Planning Commission Regular Meeting

Monday, November 10, 2025, 6:30 PM
106 Center Street

1. Call to Order
2. Roll Call
3. Minutes of the Preceding Meeting(s)
 - A. August 25, 2025 Minutes
4. Discussion Items
 - A. Residential Review Permit and Variance Applications - 163 Second Street (PC No. 2025-09)
 - B. Residential Review Permit and Variance Applications - 174 West Lake Street (PC No. 2025-10)
5. Communications and Reports
 - A. Council Updates
 - B. Upcoming Items
6. Miscellaneous
7. Adjournment

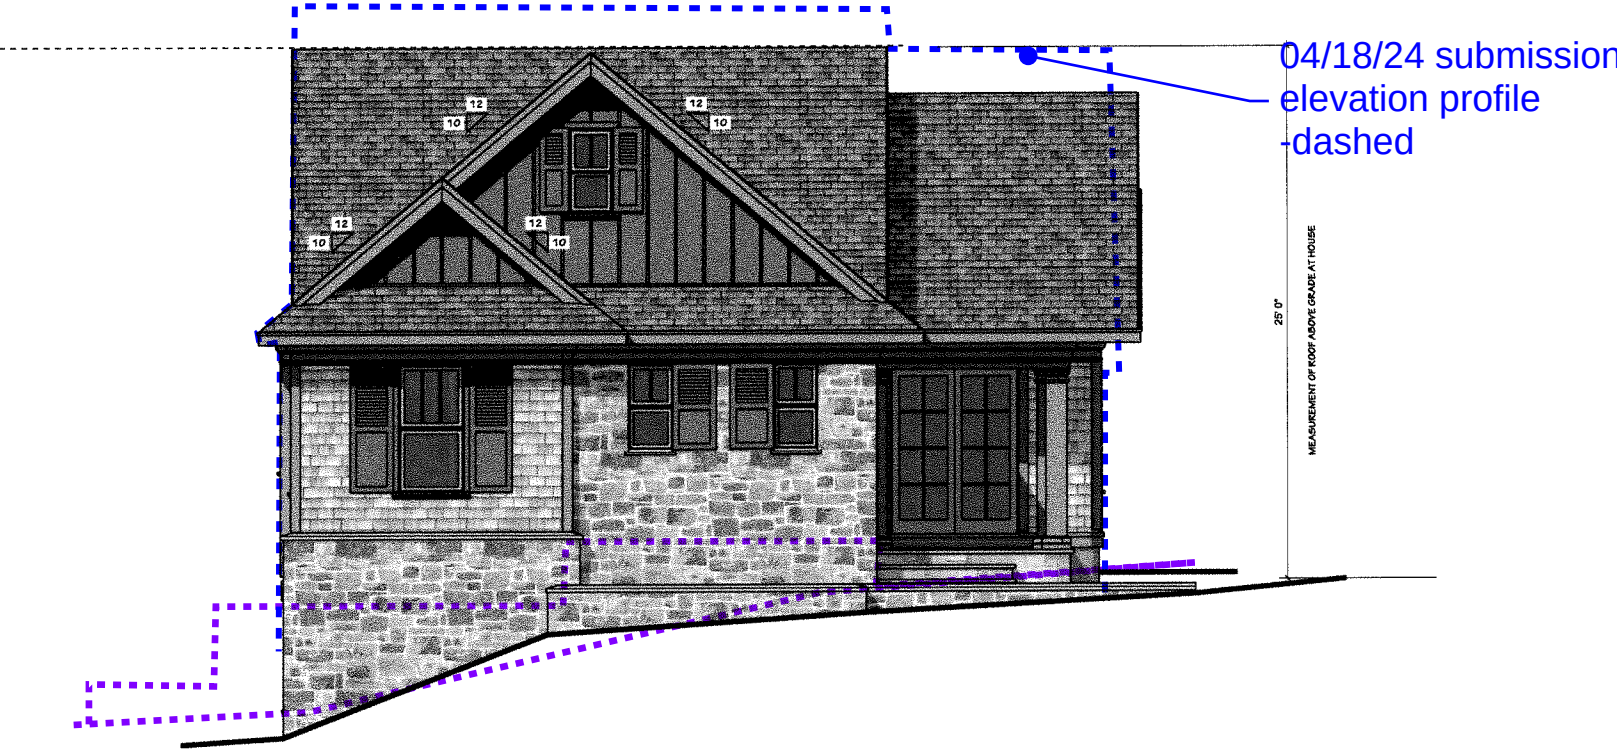
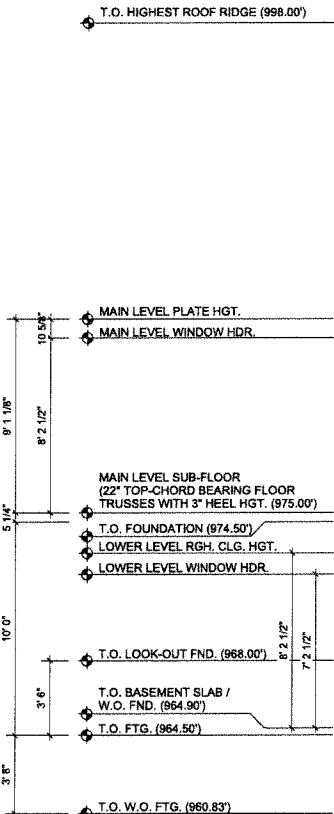
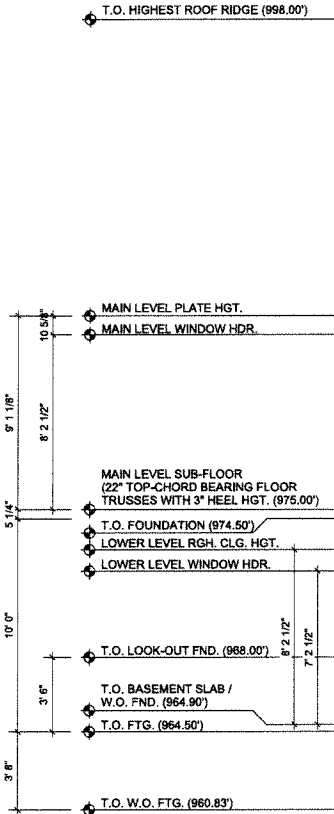
The house and front retaining walls as shown respond to the difficult existing slopes. The previous stepping front/west retaining walls have been reduced to one retaining wall planter at the front. The previous rear retaining wall has been reduced in length and height and is about 2-6 feet high.

A one-level recessed entry porch element faces 2nd street and serves as an entrance porch.

04/18/24 submission elevation for comparison

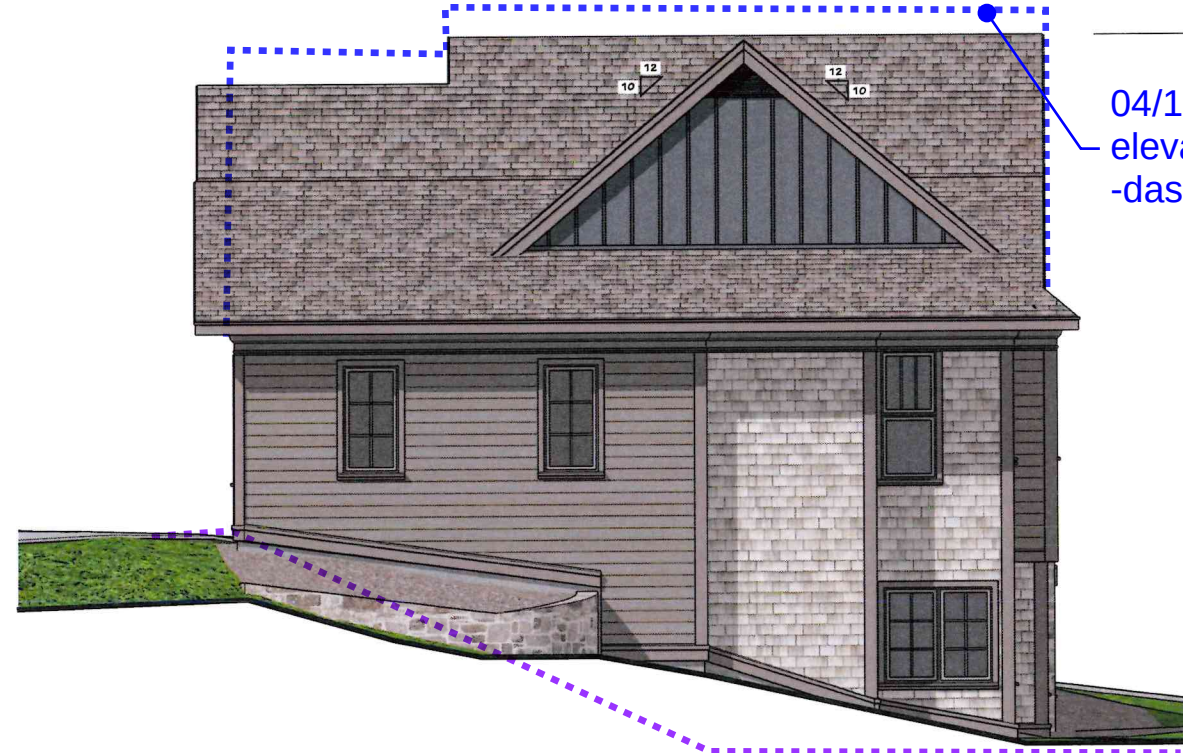
The windows, trim, and materials shown in elevations indicate detailed four-sided design. Stone and shingle materials dominant at front and right side are included at the left and right elevations. The rear elevation is improved with a larger roof gable, more articulation and windows than the previous submission.

3 Side Elevation
A1.0 1/4" = 1'-0"

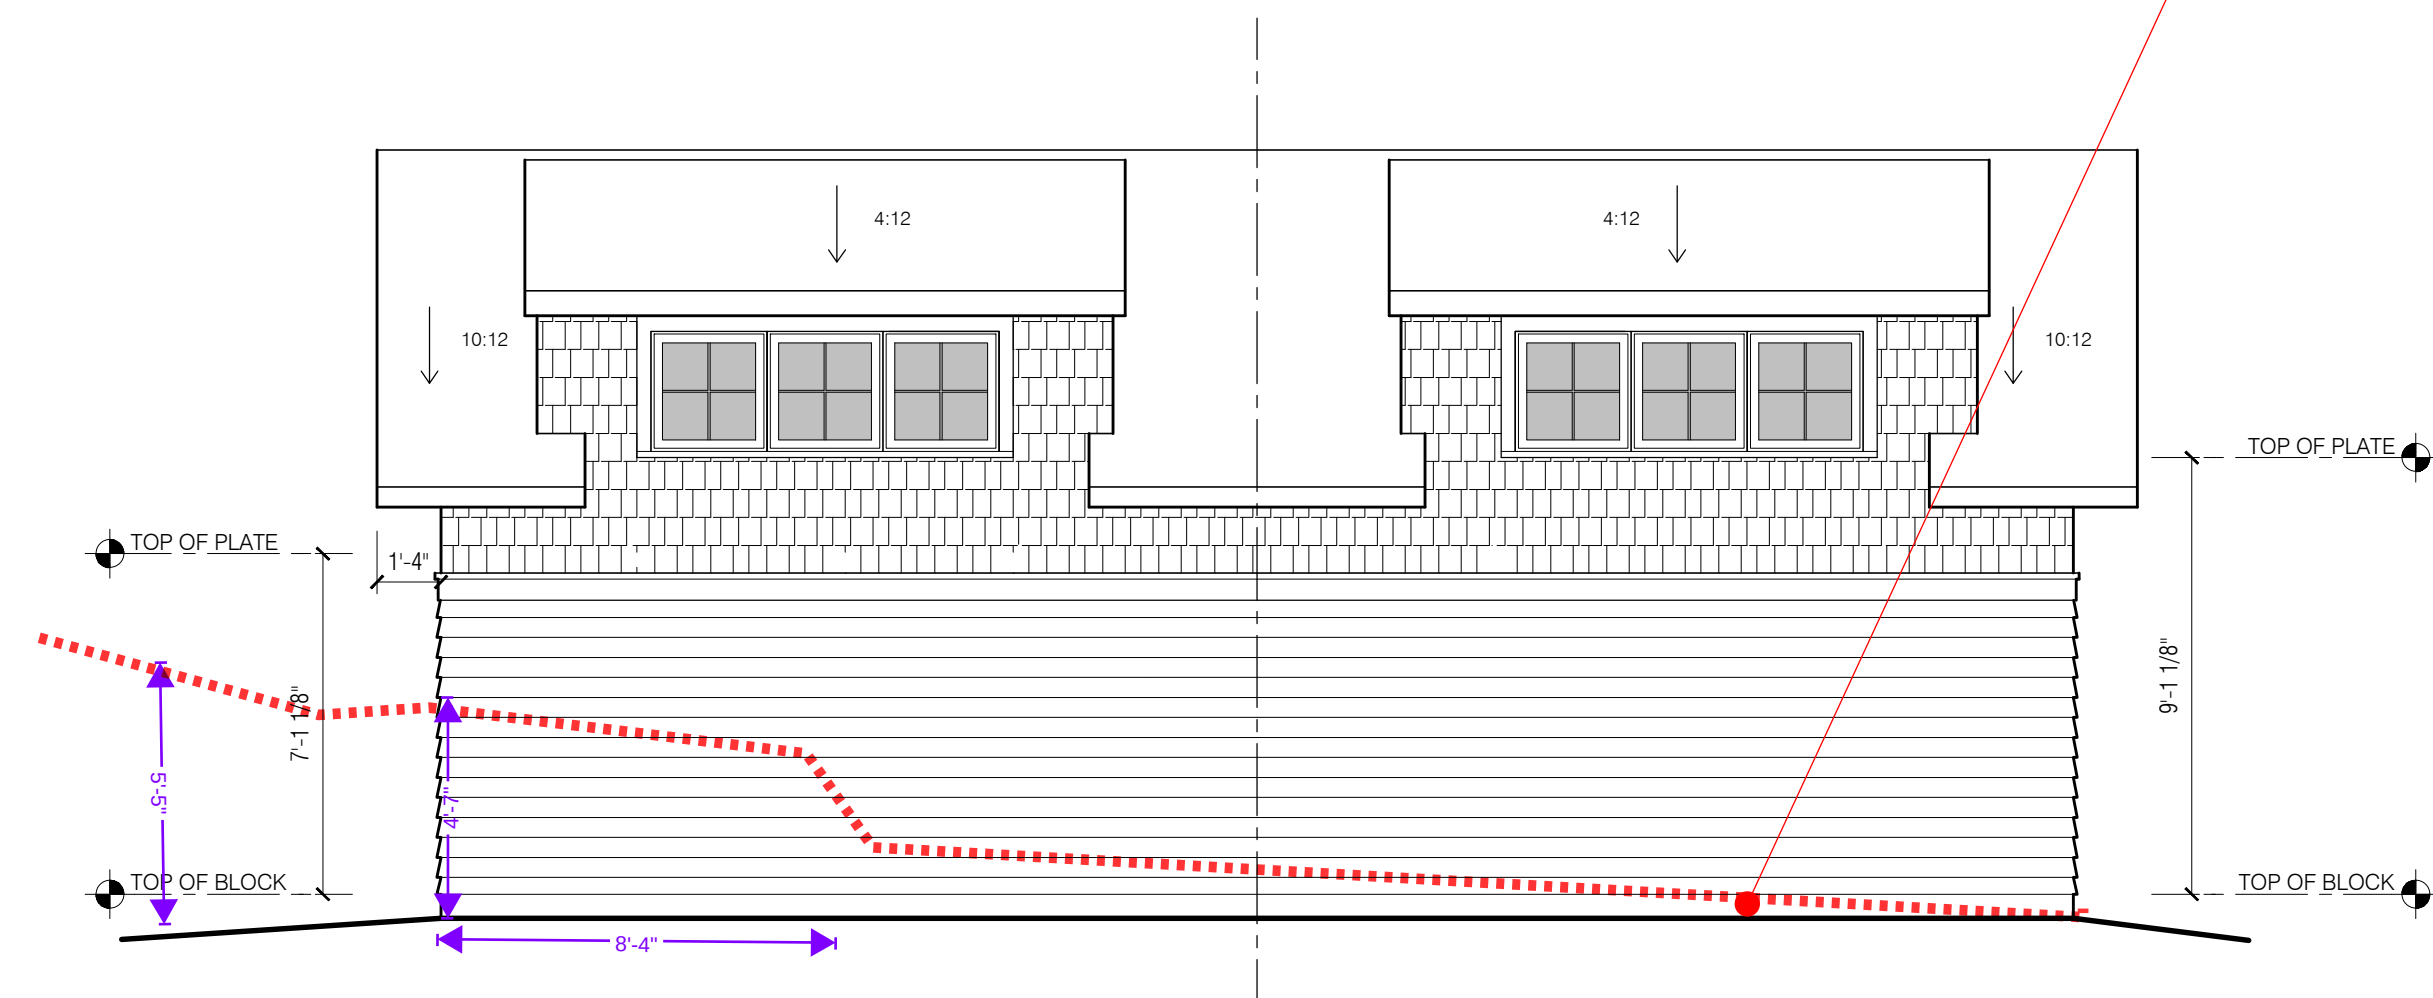
The project proposes demolition of an existing garage and construction of a new garage. The existing garage extends over the street side property line about 6.4 feet. The proposed new garage is pushed back an additional 4-0'. Extending beyond the property line about 2.4', it aligns approximately with the adjacent existing garage to the right at 162 West Lake Street. There are several existing garages along West Lake street that also extend beyond the front property line (***as shown in the attached aerial drawing***).

BLUE
DASHED
LINE
SHOWS
EXISTING
GARAGE
PROFILE

RED DASHED
LINE SHOWS
APPROXIMATE
PROPOSED
GRADE

Certificate of Survey
Prepared for
Dandery Building Corp.

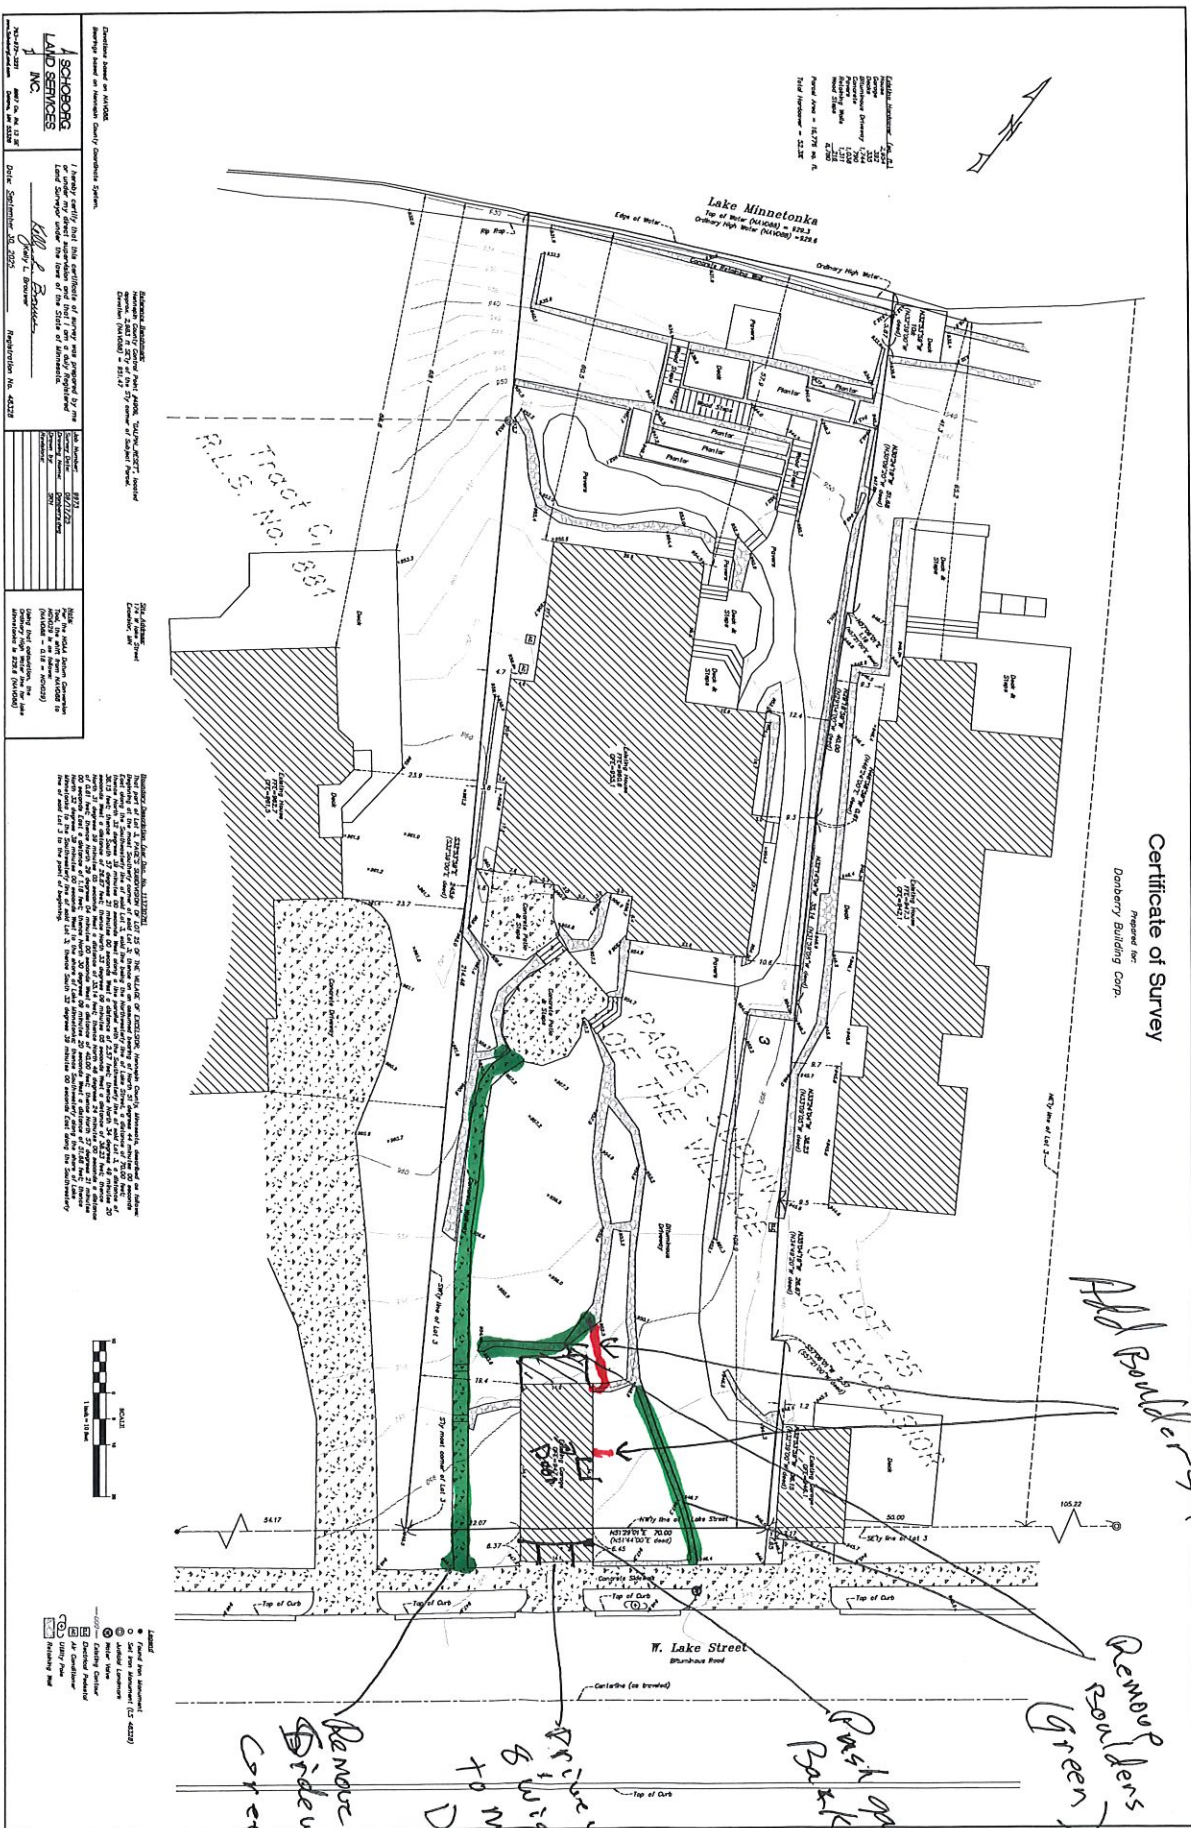
Add Roulfers (red)

Remove Roulfers (green)

Remove sidewalk & match to Door

Remove sidewalk
